Application No.: 10/702345

Case No.: 58970US002

**REMARKS**

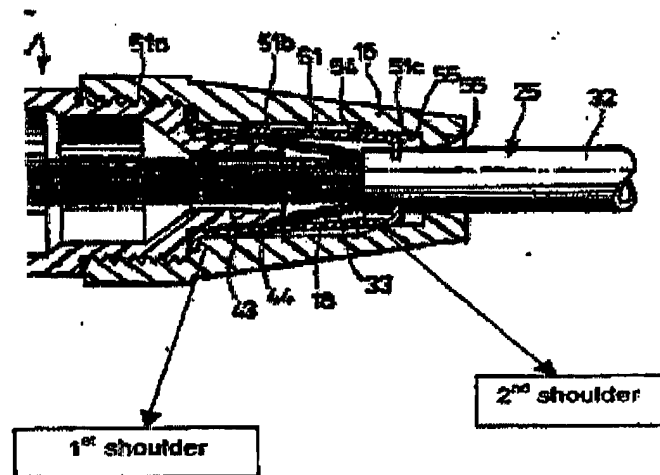
Regarding claim 2, the fiber optic cable including an optical fiber (31) in the jacket, Regarding claim 3, wherein the anchor cavity comprising a second shoulder (see the figure below), wherein the housing comprising an optical fiber outlet (56), and wherein the second shoulder is engaged with the anchor to prevent the anchor from exiting the housing through the optical outlet.

Abendschein does not disclose an anchor mounted between a first and second shoulder. Accordingly, the reference does not describe every element of the claimed invention. The Examiner states that Abendschein discloses an anchor including an inner sleeve (17) and an outer sleeve (18) and housing (16), with first and second shoulders as indicated in the following graphic from the Office Action.

As can be seen from the graphic, neither element 18 nor element 17 is between the shoulders.
